S E R V I C E N O T E

37722A Digital Telecom Analyzer

Never ending user programmable measurement test time (gates continuously)

A2 Component Location Layout

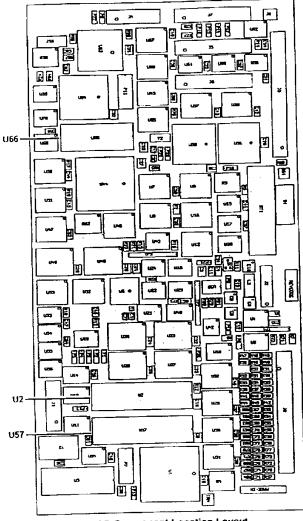
Instruments below serial number 3106U00147 which have a FIRMWARE REVISION NUMBER (MAIN) of less than 3135 have the following bug:

Bug: When a measurement test time is set for more than 1 hour using USER PROGRAM-MABLE, the instrument never stops gating.

Part No.	Prom Location - A2 Assy
37722-80018	A2U2
37722-80016	A2U66

A2U57

37722-80019

If a customer complains of the above problem, order and retrofit the following PROM parts. The Service Manual (p/n 37722-90001) comes with an Upgrading Instrument Function Section (Chapter 7, pages 7-1/2/3/4) which can be used to access, and replace the parts.

Once retrofit is complete, perform instrument self-tests to confirm operation.
